Sent: 05 January 2025 17:00
To: Planning
Subject: Ref: DC/24/1889 (Willow Croft)

Ref: DC/24/1889 (Neighbour Comment)

Windows on side elevation (as per image below)

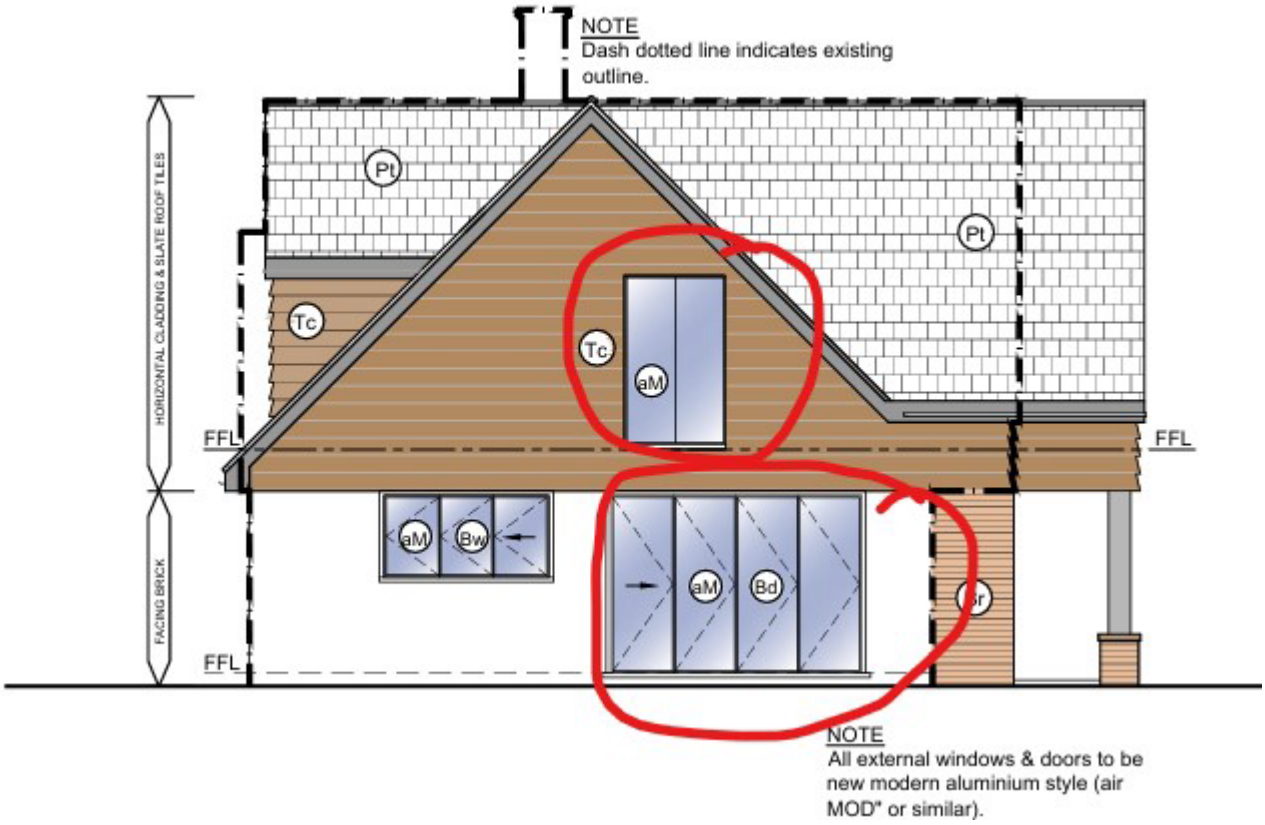
Currently there are no windows on the existing side elevation.

Point 1 (Loss of Privacy): Proposed floor to ceiling window on first floor will overlook our side and rear patio/garden - impacting our privacy (currently not overlooked). Possible solutions: (a) remove window (b) window to be obscure glazed and fixed (not able to open).

Point 2 (Increased Noise): Proposed ground floor sliding/folding doors will increase noise levels projected towards our property (would be compounded further if patio area is created). Possible solutions: (a) remove sliding/folding doors (b) relocate sliding/folding doors to front elevation.
